DURHAM COUNTY

I-40 and Miami Blvd.

Date: April 4, 2017	County: Durham
Interchange: I-40 and Miami Blvd.	
Location (exit ramp): EB Exit Ramp

Brookshire Freeway EB Exit Ramp at Beatties Ford Rd.

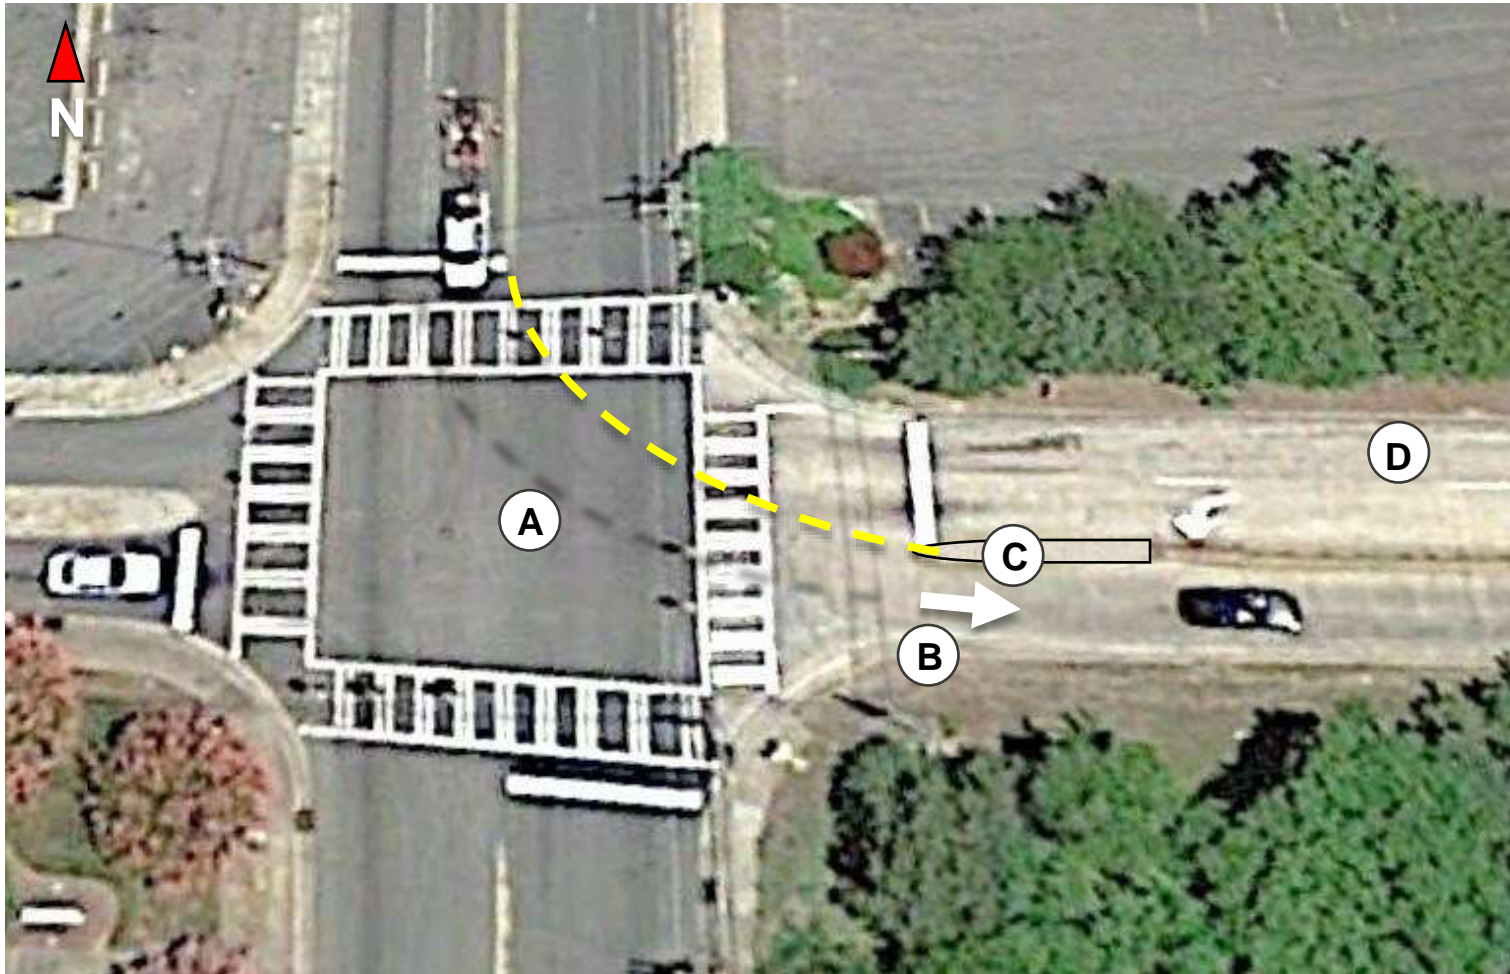
- A. Add dotted lane line extension through intersection
- B. Add arrow indicating correct freeway entrance point
- C. Extend raised median
- D. Add wrong way arrows

Brookshire Freeway WB Exit Ramp at Beatties Ford Rd.

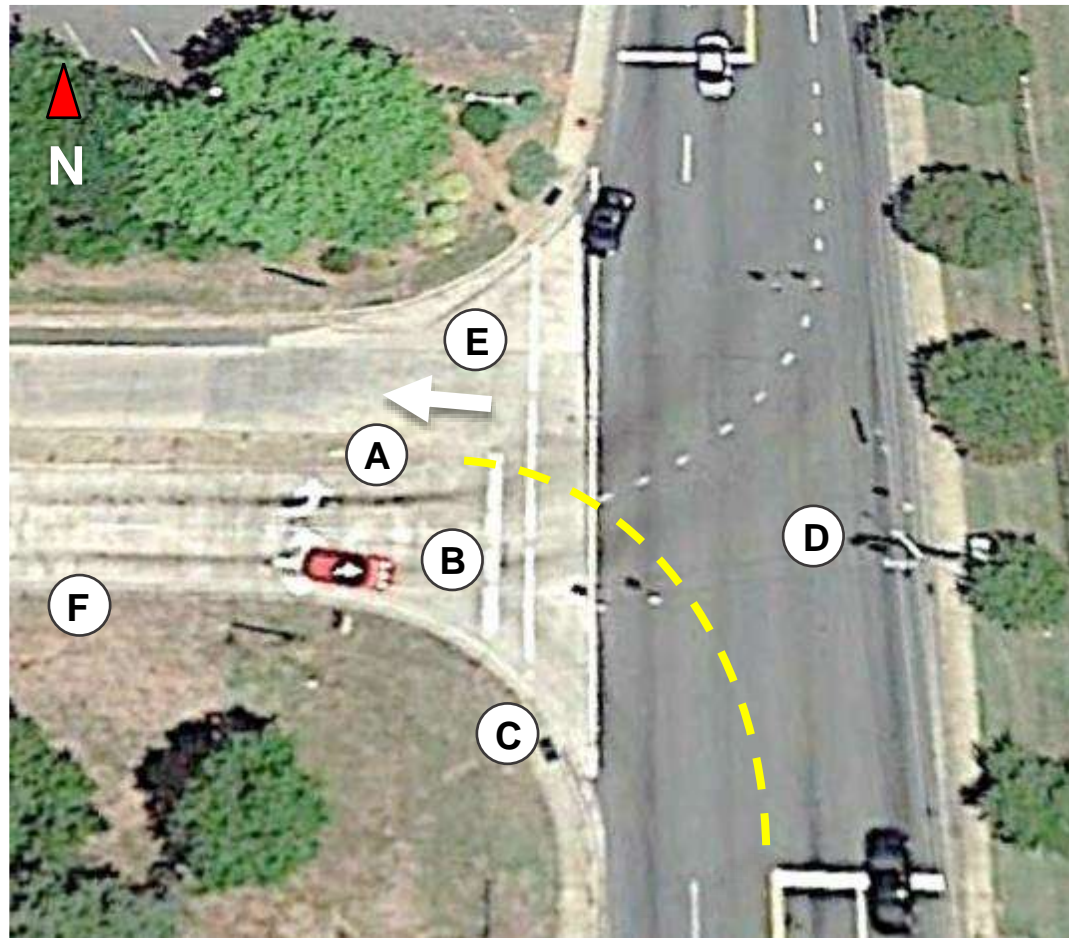
- A. Improve median visibility and add splitter sign
- B. Repair stop bar and turn arrows
- C. Add One-Way sign
- D. Add dotted lane line extension through intersection
- E. Add arrow indicating correct freeway entrance point
- F. Add wrong way arrows

I-74 EB Exit Ramp at Briar Creek Rd.

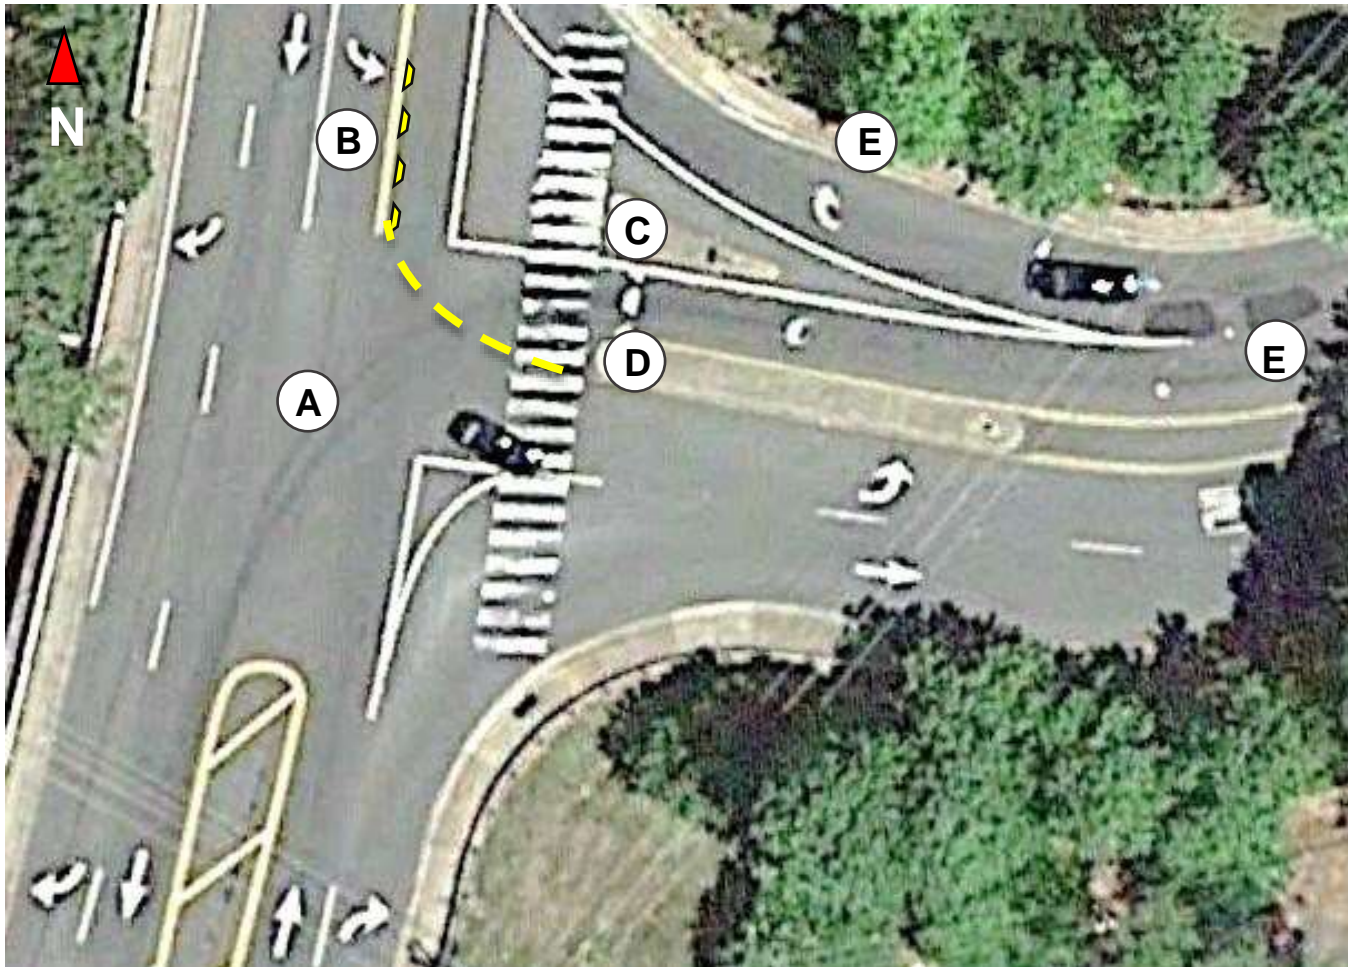
- A. Add dotted lane line extension through intersection
- B. Add raised separator
- C. Add One-Way sign
- D. Add splitter sign, improve median visibility
- E. Add Wrong Way arrows

I-74 WB Exit Ramp at Briar Creek Rd.

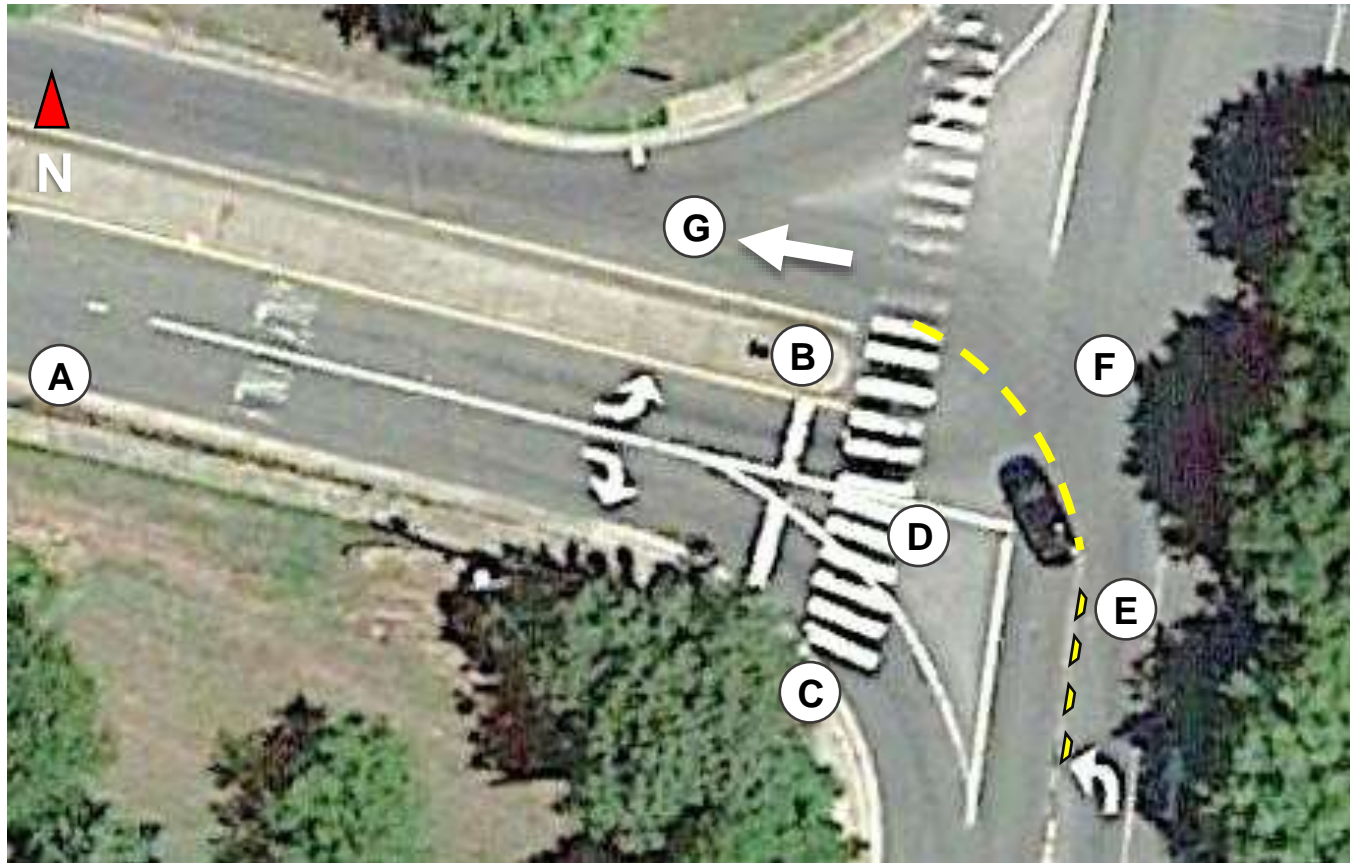
- A. Add Wrong Way arrows
- B. Improve visibility of median
- C. Move Do Not Enter sign forward, add One Way sign
- D. Repaint crosswalk, pork chop island, and turn arrows
- E. Replace and extend separator
- F. Add dotted lane line extension through intersection
- G. Add arrow indicating correct freeway entry point

I-85 NB Exit Ramp at Sam Wilson Rd.

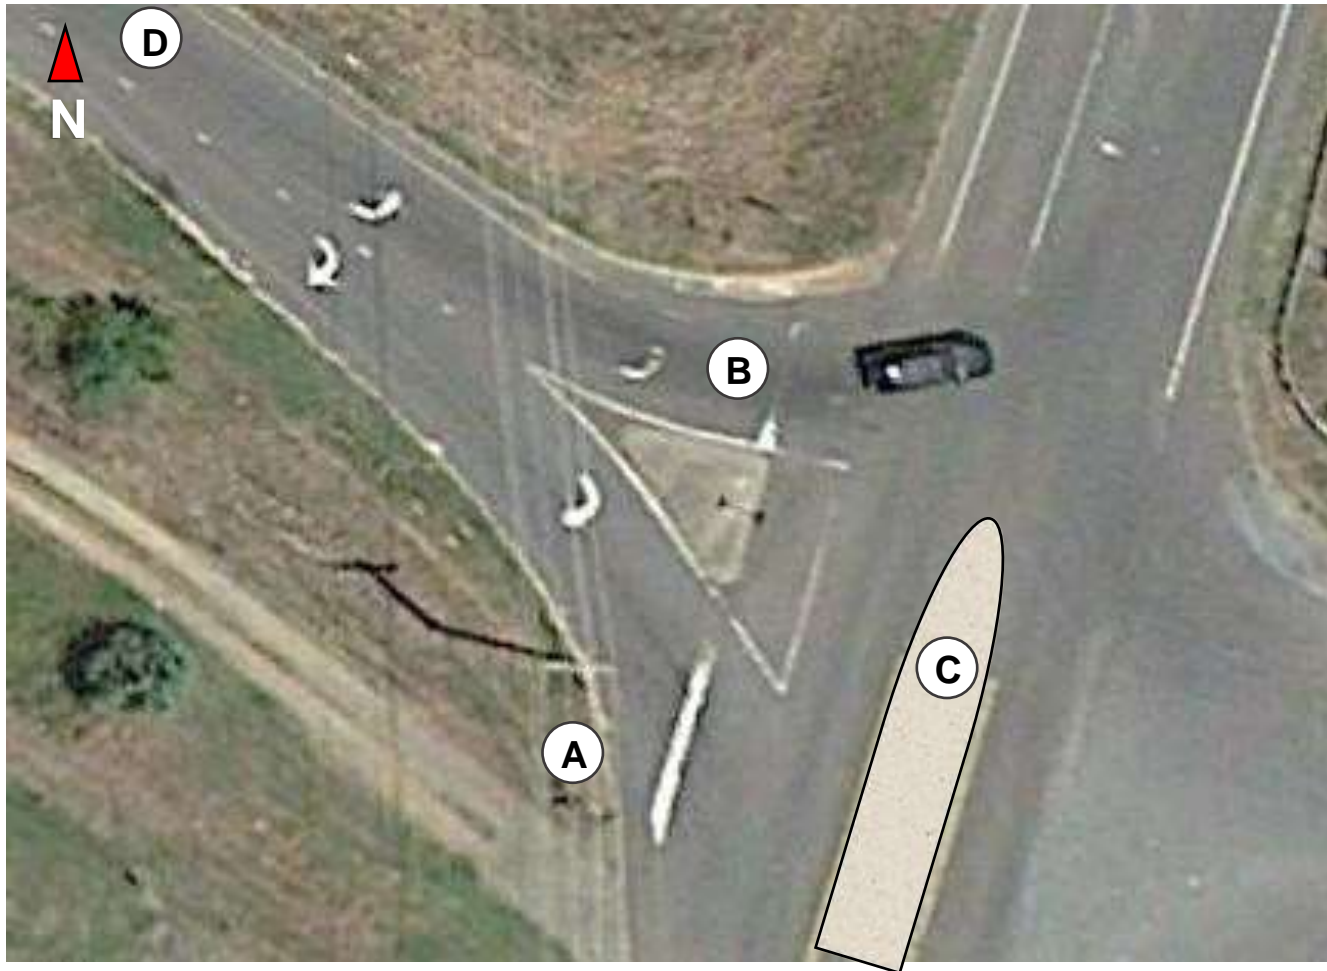
- A. Reinstall Do Not Enter sign
- B. Repaint stop bar
- C. Add raised median or repaint hash lines
- D. Add Wrong Way arrows

I-85 SB Exit Ramp at Sam Wilson Rd.

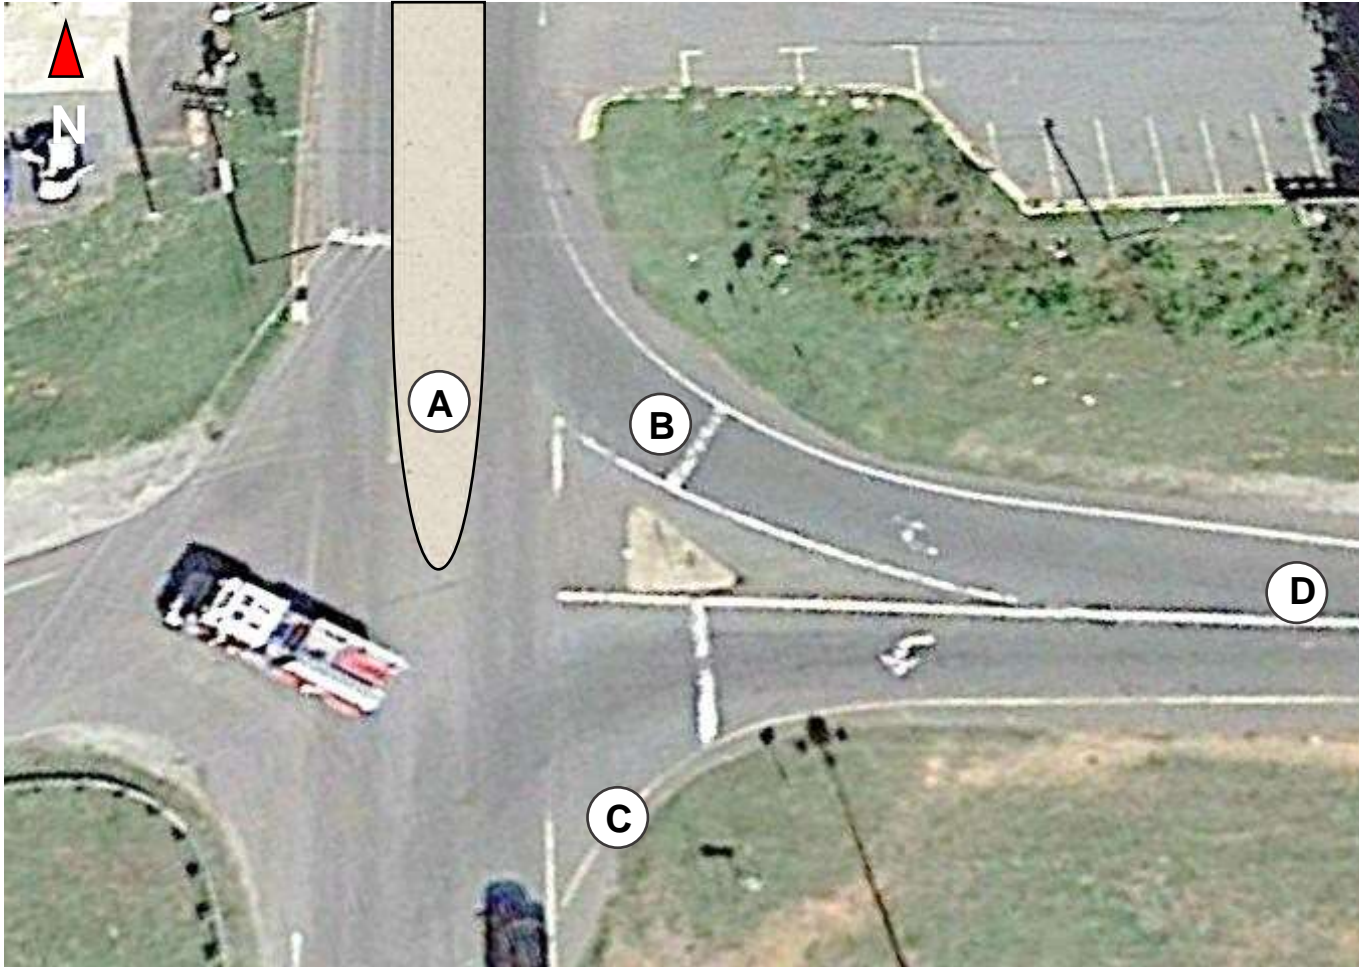
- A. Add raised median or repaint hash lines
- B. Repaint stop bars
- C. Tighten corner radius
- D. Add Wrong Way arrows

I-485 NB Exit Ramp at Idlewild Rd.

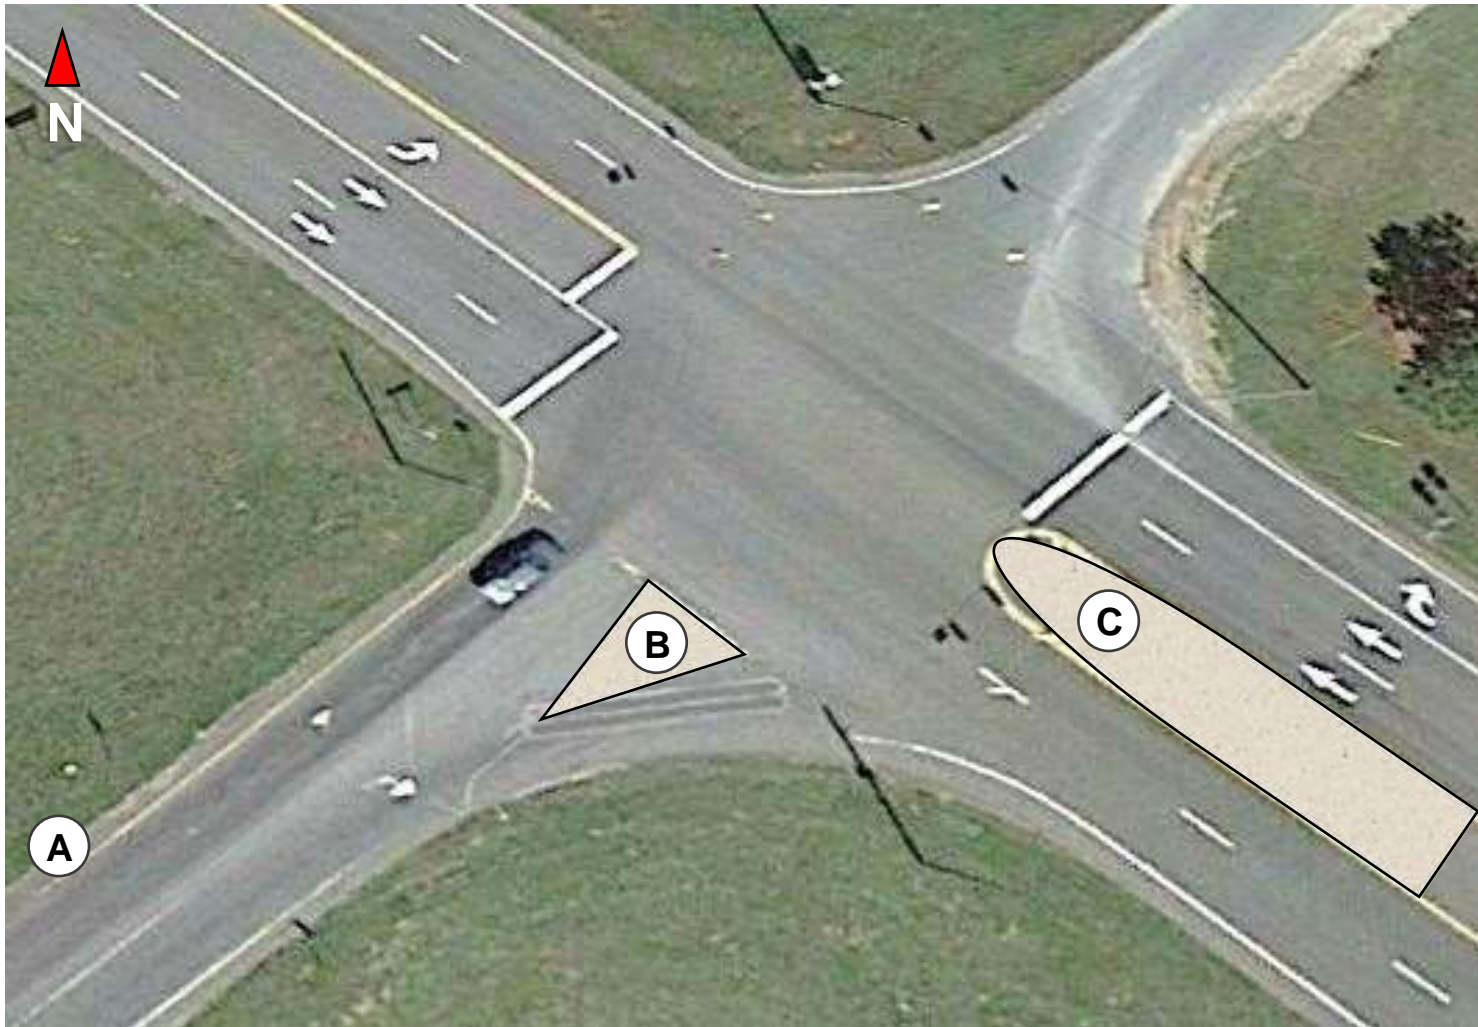
- A. Add Wrong Way arrows
- B. Install splitter island
- C. Add raised median

I-485 SB Exit Ramp at Idlewild Rd.

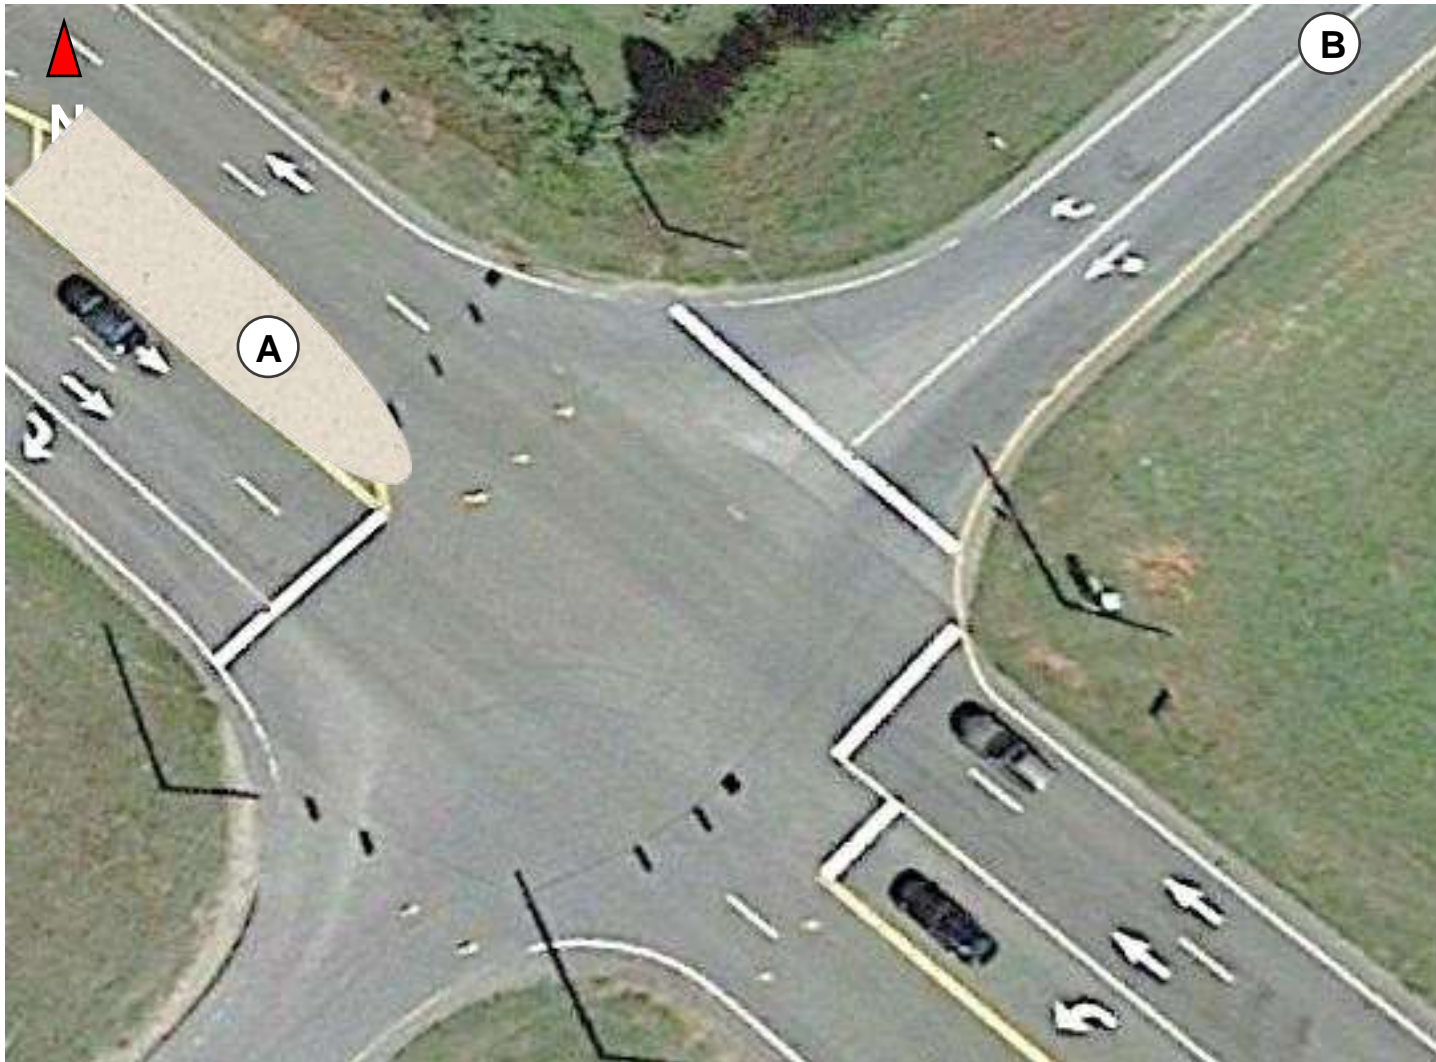
- A. Install raised median**
- B. Add Wrong Way arrows**
